# Groundwater Transfer Review Summary Form

Transfer/PA # T- 13270

Application: T-13270

Applicant Name: City of Echo

Wells in Echo Heights

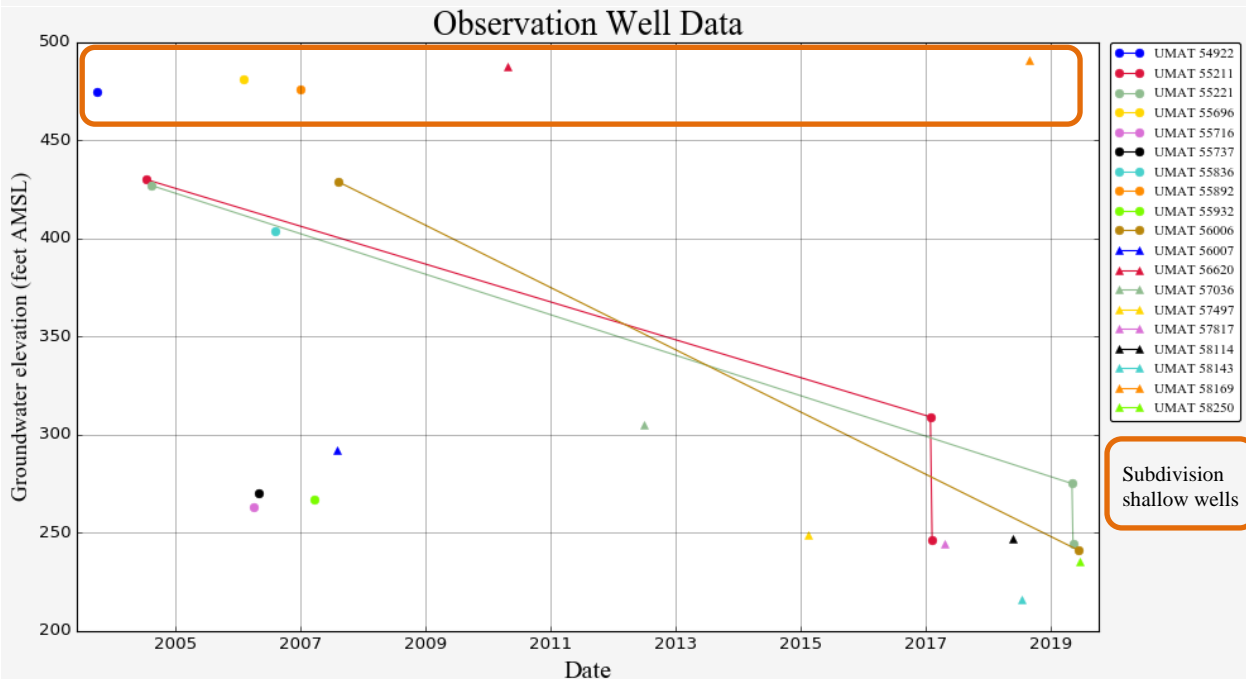
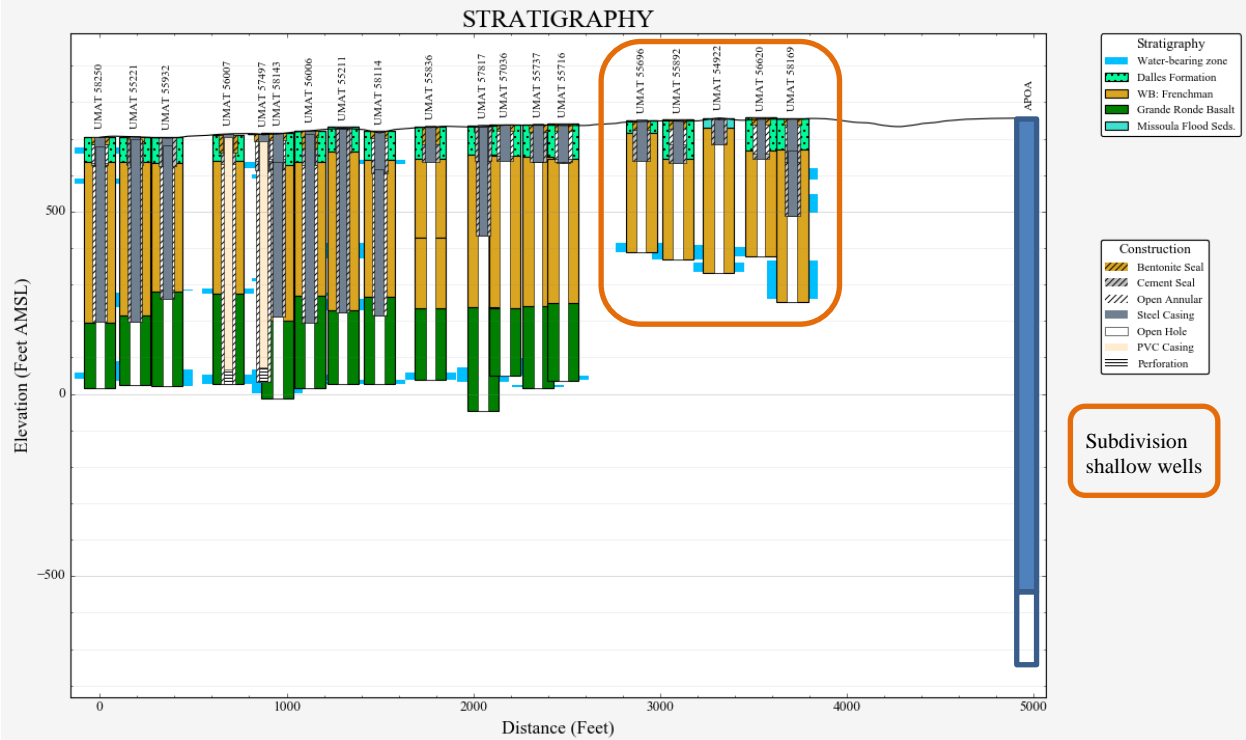
8. Any additional comments: The proposed new well, at either location, is near the Echo Heights subdivision, which contains many domestic wells. The domestic wells of Echo Heights are approximately 700 feet deep or less. Presumably, the deep proposed (continuous) casing and (continuous) seal (1275 feet below land surface) and proposed total depth (1500 feet below land surface) are intended to prevent interference with the domestic wells and nearby irrigation wells. Once the new well is constructed (as per item 7 above), the new well will demonstrate either a) that it is producing from a distinctly different aquifer than nearby Echo Heights wells and permitted irrigation wells, or b) that it is producing from the same aquifer as the nearby Echo Heights wells and permitted irrigation wells.

**Regional Wells from Critical Groundwater Area Subarea A**

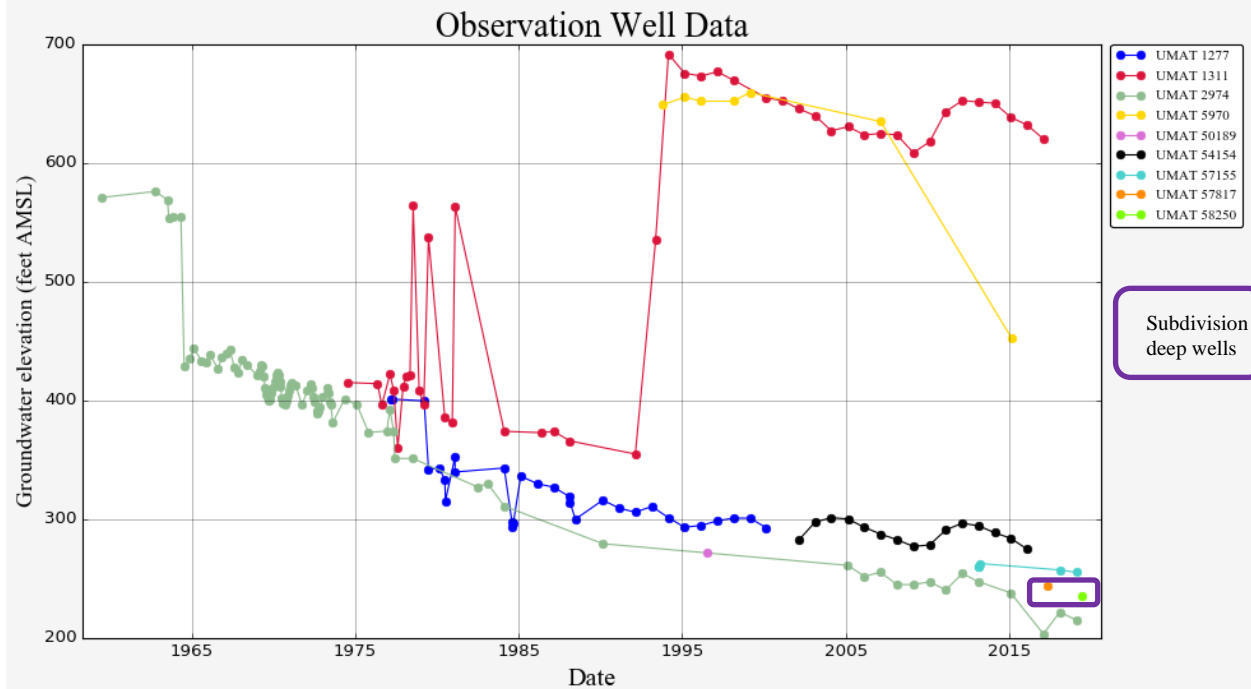
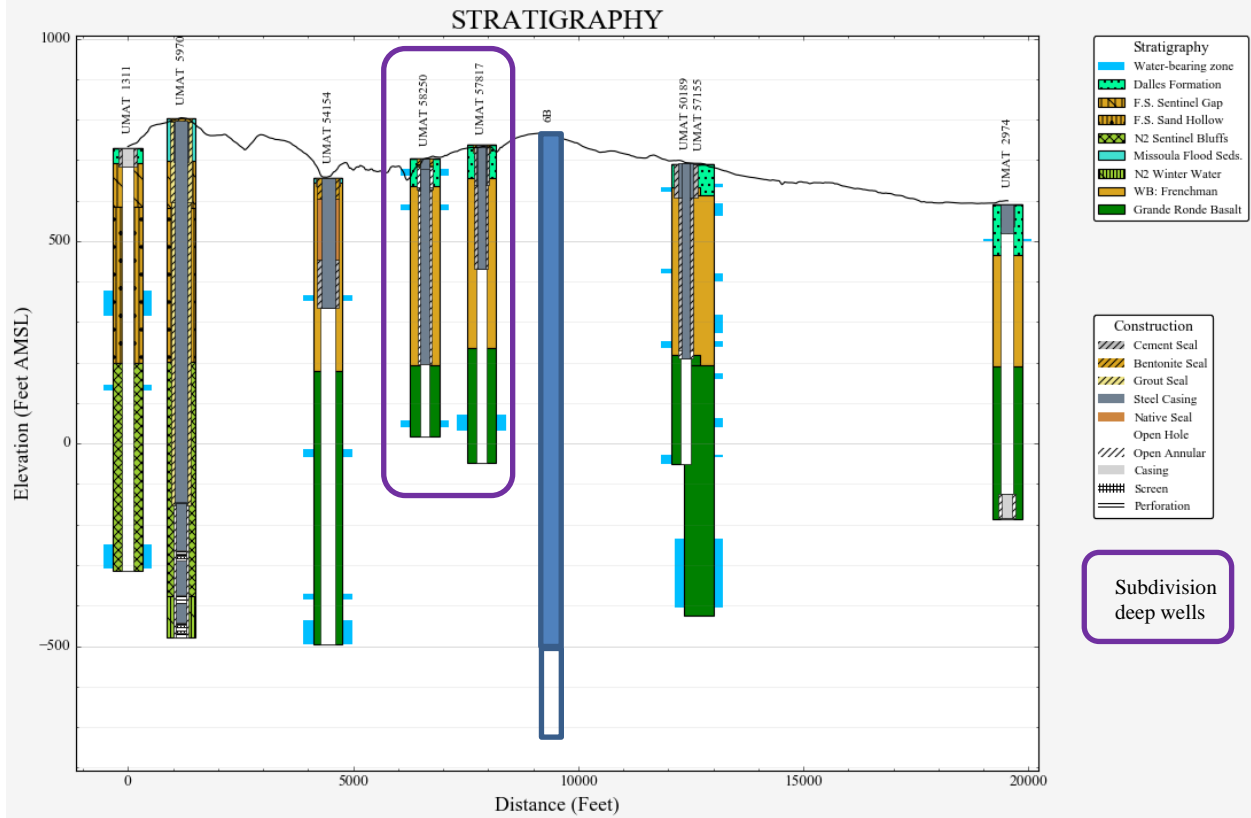
2. Will the proposed POA develop the same aquifer (source) as the existing authorized POA?  
 Yes  No Comments: Both authorized wells (Well 4: UMAT 1311/5841 and Well 2: UMAT 1314/1313) are physically located within the Stage Gulch Critical Groundwater Area Subarea A. However, it appears that the 1992 deepening of Well 4 (UMAT 1311 originally 600 feet deep, deepened to 1045 feet under log UMAT 5842) connected Well 4 (UMAT 1311/5842) with the aquifer of the Stage Gulch Critical Groundwater Area Subarea D or Subarea H. Another City well, Well 5 (UMAT 5970, constructed in 1994 and 1282 feet deep), also appears connected to the aquifer of Subarea D or Subarea H. Both Well 4 (UMAT 1311/5842) and Well 5 (UMAT 5970) are located in close proximity to a mapped fault. This fault appears to act as a groundwater conduit, at a depth greater than 600 feet below land surface. Regardless, past practice has been to treat all basalt wells within Subarea A as same source.

3. a) Is there more than one source developed under the right (e.g., basalt and alluvium)?  
 Yes  No Both wells authorized under Permit G-8546 are producing from basalt aquifers. Water level data indicates that Well 2 (UMAT 1314/1313) is producing from the same basalt aquifer as the other wells in Stage Gulch Critical Groundwater Area Subarea A. It appears that Well 4 (UMAT 1311/5842) was producing from the same basalt aquifer as other wells in Subarea A until it was deepened in 1992 from 600 feet to 1045 feet. At that time it appears that Well 4 became hydraulically connected to wells in Stage Gulch Critical Groundwater Area Subarea D or Subarea H, based on annual water level data.

Projected Well-to-Well Interference at UMAT 55716 from proposed Well 6B.

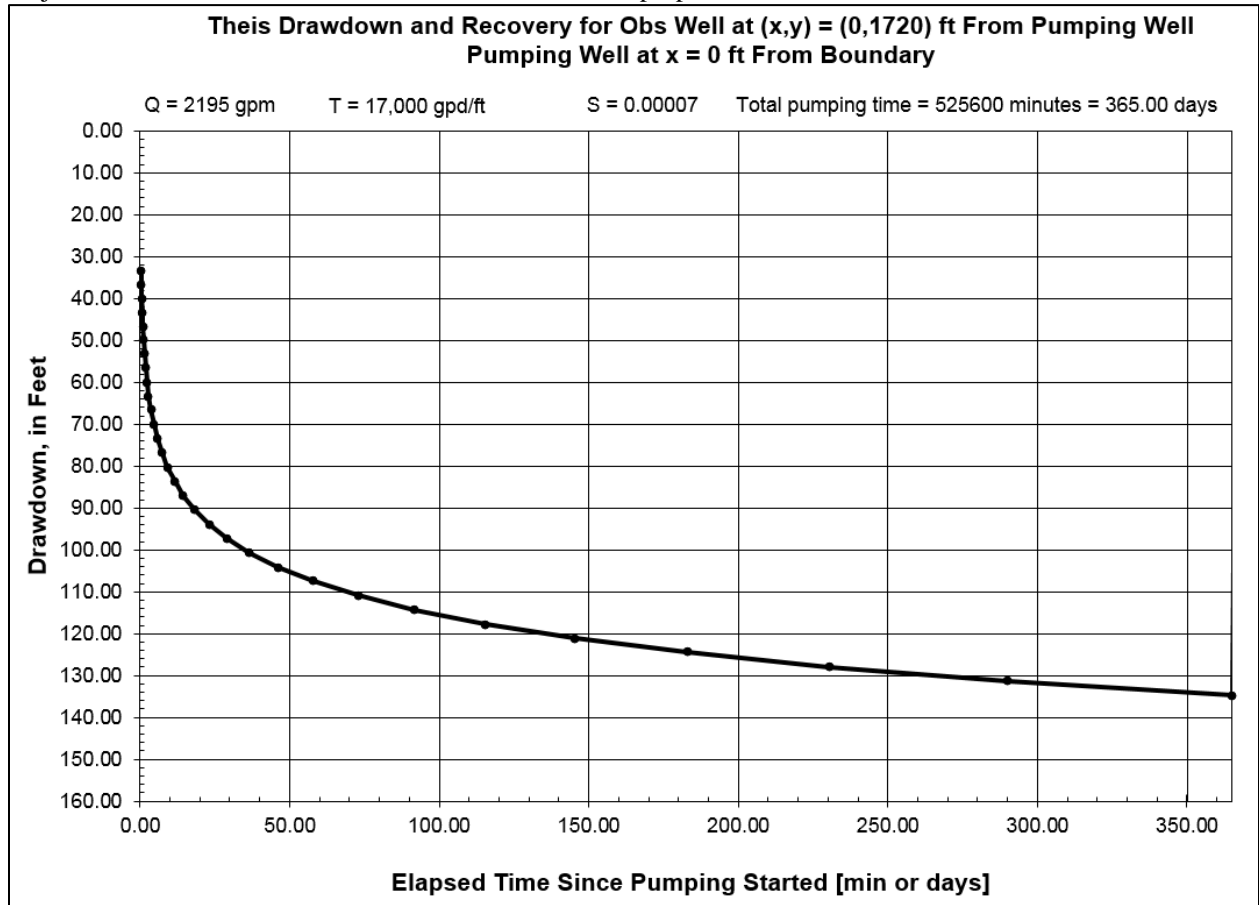
On the other hand, if the new well is producing from the same aquifer as the nearby wells then there is potential for hydraulic interference with the nearby wells. Theis drawdown modeling indicates that drawdown at UMAT 55716 (the Echo Heights deep well closest to either proposed location for Well 6) could be up to approximately 135 feet due to pumping at proposed Well 6B, or approximately 128 feet due to pumping at proposed Well 6A (see Theis Drawdown Analysis below), after a year of continuous pumping. The transmissivity value used in these models is derived from a pump test at UMAT 2075, located in the town of Hermiston. UMAT 2075 is the only basalt well within the Stage Gulch Critical Groundwater Area which has analyzable pump test results. **However, taking into account the content and results of a recent contested case (OAH Reference No. 2019-OWRD-00027, hearing on 05/28/2020), the proposed transfer will not result in injury to the nearby wells if the nearby wells are not reasonably efficient and/or do not fully penetrate the aquifer. If the new well (constructed as per item 7) is producing from the same aquifer as the nearby wells, this will demonstrate that the nearby wells are not fully penetrating the aquifer.**

Distance from Pumping Well to Affected Well (UMAT 55716) (x, y): 0, 1720 feet [from proposed well 6B]

Pumping Rate (Q): 2195 gpm (4.9 cfs)

Aquifer Transmissivity (T) = 17000 gpd/ft (2272 ft<sup>2</sup>/day) [based on data from pumping test at UMAT 2075]

Aquifer Storativity (S) =  $7 \times 10^{-5}$  [based on aquifer tests in Columbia River Basalts]

Total Pumping Time = 365 days [permit G-8546 specifies 4.9 cfs {2.9 cfs from well #1 and 2.0 cfs from well #4} with no duty listed, therefore the presumptive use could be pumping at 2195 gpm 24 hours a day, 365 days a year]

If this transfer goes through, a constant-rate aquifer test should be conducted to determine aquifer properties locally. The test should be designed and conducted by an Oregon Registered Geologist but the test design should be subject to the approval of the Groundwater Section of the Department prior to the test. The test should have a duration of at least 24 hours, and should include discharge measurements in the pumping well and water level measurements in the pumping well and other permitted wells. If practicable, water level measurements should also be made in nearby wells that are not on the permit. If permission is granted, either UMAT 1277 or UMAT 54154 would be good to monitor during the aquifer test, along with deep wells in the Echo Heights subdivision.

Projected Well-to-Well Interference at UMAT 55716 from proposed Well 6A.

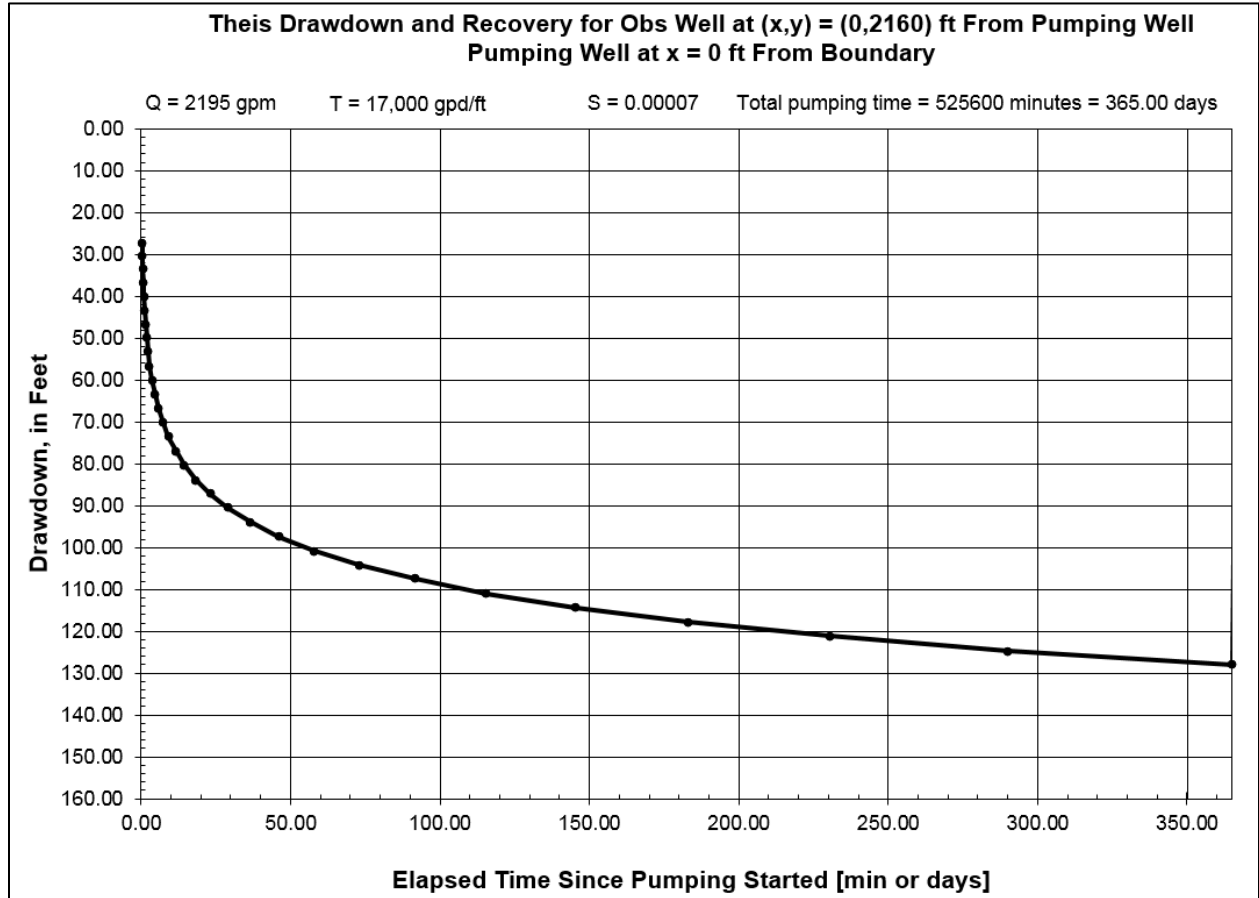
Distance from Pumping Well to Affected Well (UMAT 55716) (x, y): 0, 2160 feet [from proposed well 6A]

Pumping Rate (Q): 2195 gpm (4.9 cfs)

Aquifer Transmissivity (T) = 17000 gpd/ft (2272 ft<sup>2</sup>/day) [based on data from pumping test at UMAT 2075]

Aquifer Storativity (S) = 7x10<sup>-5</sup> [based on aquifer tests in Columbia River Basalts]

Total Pumping Time = 365 days [permit G-8546 specifies 4.9 cfs {2.9 cfs from well #1 and 2.0 cfs from well #4} with no duty listed, therefore the presumptive use could be pumping at 2195 gpm 24 hours a day, 365 days a year]
